Appl. No.: 09/753,011

For: METHOD OF MAKING UNIFORM
OXIDE LAYER

RESPONSE

Figure 1

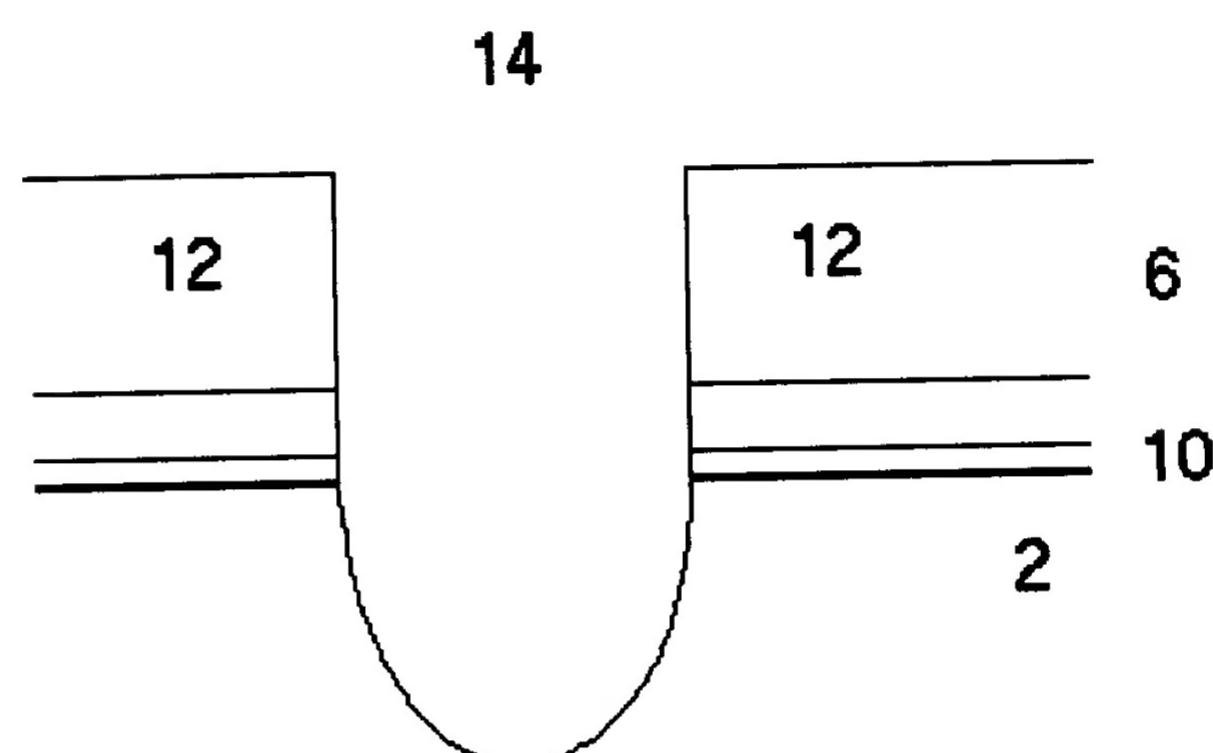
Figures 1-5 have been amended to show that the isolation technique illustrated is conventional. Amendments are made in red.

Conventional
